RE: Former Exxon RAS #7-0235/2225 Telegraph Avenue, Oakland California.

April 26, 2004
ERI 222914.W04

Subject: Addendum to *Response to Agency Comments and Addendum to Preferential Pathway Study and Work Plan for Off-Site Delineation*, Former Exxon Service Station 7-0235, 2225 Telegraph Avenue, Oakland, California.

GENERALIZED SITE PLAN
 FORMER
 EXXON SERVICE STATION 7-0235
 2225 Telegraph Avenue
 Oakland, California

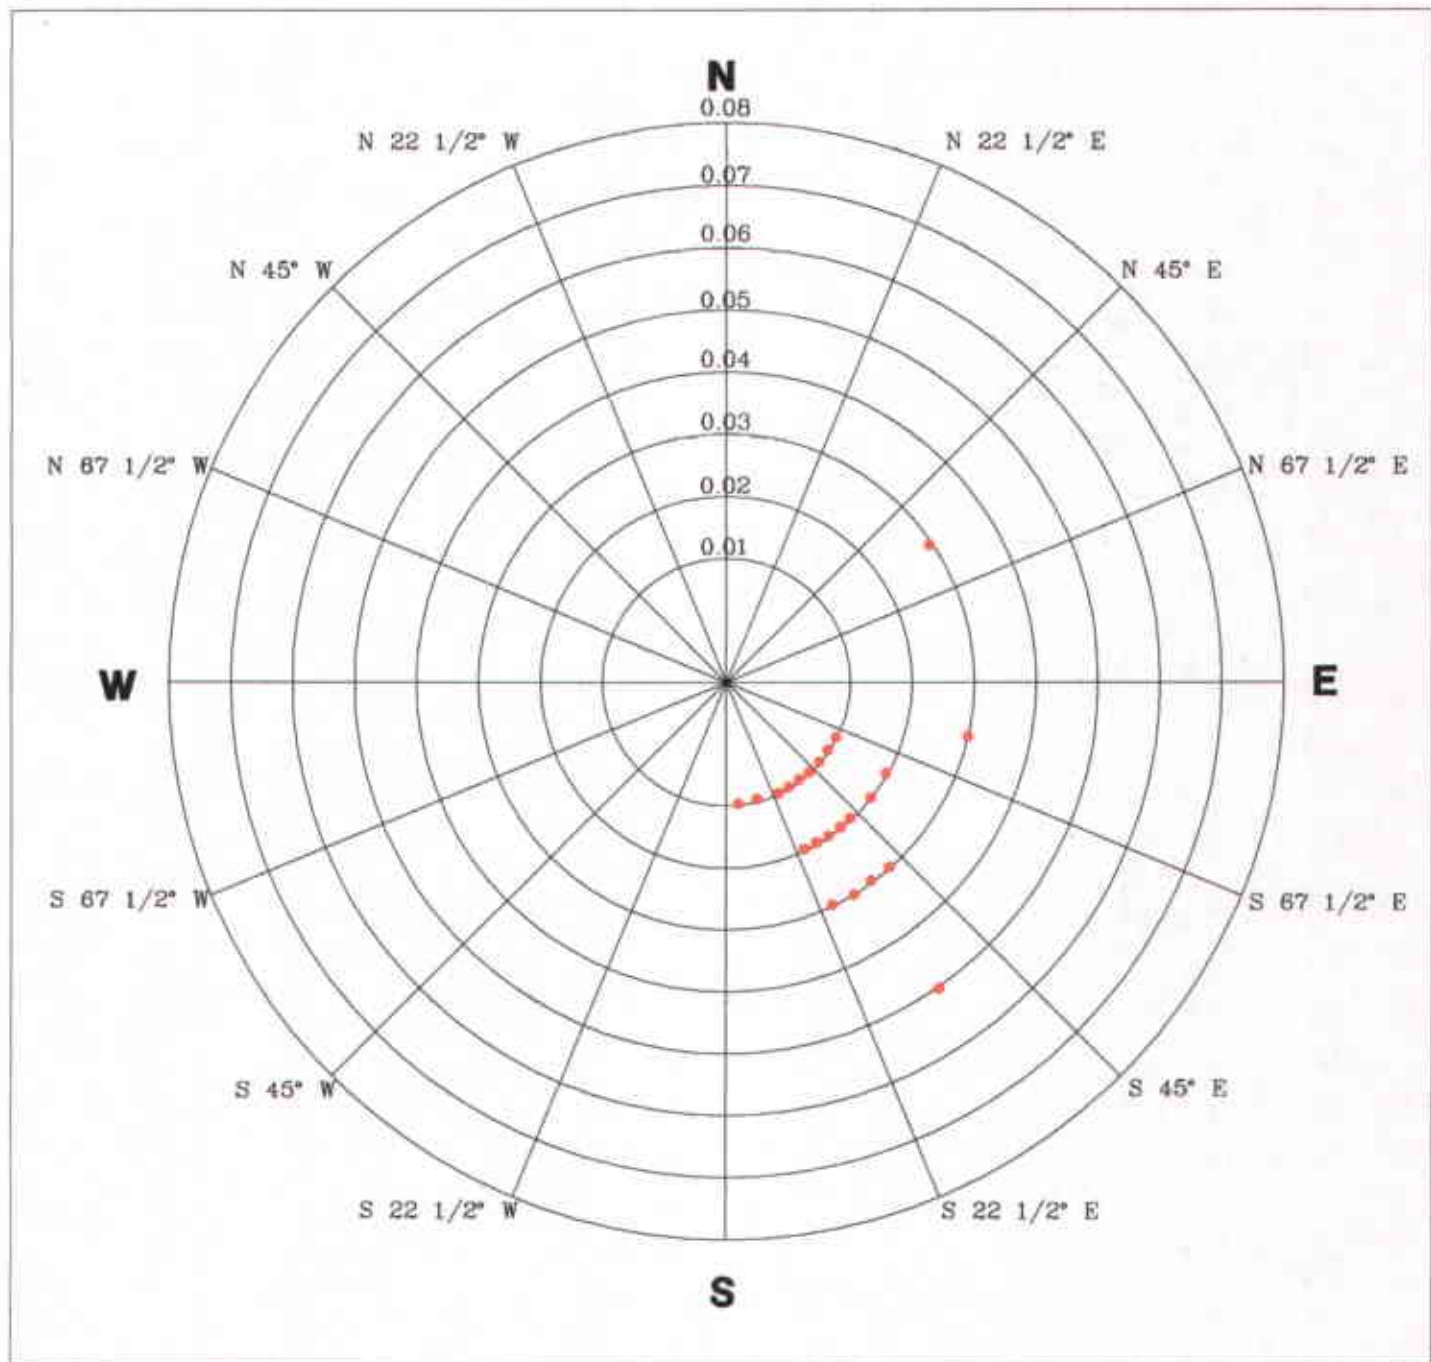
Proposed Locations off-site soil borings (B5 through B7): The proposed locations for B5 and B6 are acceptable. The proposed location of B7 appears to be where GP2 was collected when 100 ug/l of total petroleum hydrocarbons as gasoline (TPHg) was detected at 12 feet. Therefore, a different location ought to be selected. We request that depth discrete grab groundwater sampling be used. Please propose additional grab groundwater sampling locations to determine optimal well locations.

- 1) Proposed Locations Off-site Soil Borings (B5 through B7): The proposed locations for B5 and B6 are acceptable. The proposed location of B7 appears to be where GP2 was collected when 100 ug/l Total Purgeable Petroleum Hydrocarbons as gasoline (TPPHg) was detected at 12 feet. Therefore, a different location ought to be selected. We request that depth discrete grab groundwater sampling be used. Please propose additional grab groundwater sampling locations to determine optimal well locations. Include your proposal in the Work Plan Addendum requested below.

The location of proposed soil boring B7 has been relocated approximately 30 feet southeast (downgradient) of the original proposed location. In addition, ERI proposes to advance an additional soil boring (B8), approximately 50 feet southeast of the new proposed location of soil boring B7. The

locations of the proposed borings are shown on Plate 2. Groundwater samples collected from the borings will be collected with a discrete groundwater sampling device.
